Access Compliance Report

Public Rights-of-Way

(Curb Ramps)

Intersection ID: 25832	Main Street: STRAWBERRY_LN	Cross Street: FAIRWAY_DOWNS_CT	Location: SE
ADA ID: 154FB13DFC6F	Ramp Type: PerpDiag	Initial Pass/Fail: Fail	Overall Compliance: No
Severity Score: 13.75			
Codes/Mitigation Info/Possible Solution		Field Measurements/Component Compliance

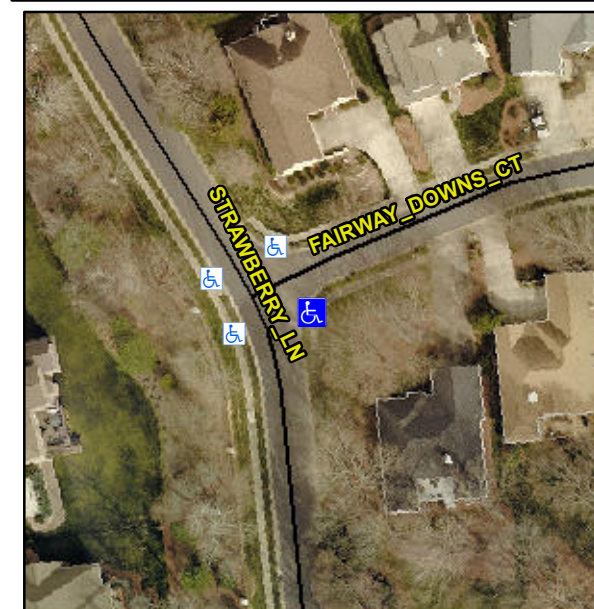
Not Found, R304.2.2, R304.5.3

Compliance	Description	Data	Compliance	Description	Data
N/A	Ramp Length (in)	48.0	No	Ramp Slope (%)	9.5
Yes	Ramp Width (in)	48.0	No	Ramp XSlope (%)	2.8
N/A	Flare Type LT	N/A	N/A	Flare Type RT	N/A
N/A	Flare Slope LT (%)	N/A	N/A	Flare Slope RT (%)	N/A
N/A	Flare Traversable LT?	N/A	N/A	Flare Traversable RT?	N/A
N/A	Landing Length (in)	N/A	N/A	DWS Provided?	N/A
N/A	Landing Width (in)	N/A	N/A	DWS Contrast?	N/A
N/A	Landing Slope (%)	N/A	N/A	DWS Length (in)	N/A
N/A	Landing X Slope (%)	N/A	N/A	DWS Full Width?	N/A
N/A	Landing Curb? (Y/N)	N/A	N/A	DWS Offset (in)	N/A
N/A	Shared Landing?	N/A			
N/A	Gutter Ponding?	N/A	N/A	Gutter Slope (%)	N/A
N/A	Gutter Lip Ht (in)	N/A	N/A	Gutter X Slope (%)	N/A
N/A	Painted X Walk1?	No	N/A	Painted X Walk2?	No
	X Walk 1 Direction	To NW		X Walk 2 Direction	To W
N/A	X Walk 1 Width (in)	N/A	N/A	X Walk 2 Width (in)	N/A
	X Walk 1 Slope (%)	3.1		X Walk 2 Slope (%)	0.8
	X Walk 1 X Slope (%)	0.9		X Walk 2 X Slope (%)	2.5

Remove & Replace Curb Ramp With Two New Directional Ramps or Equivalent.
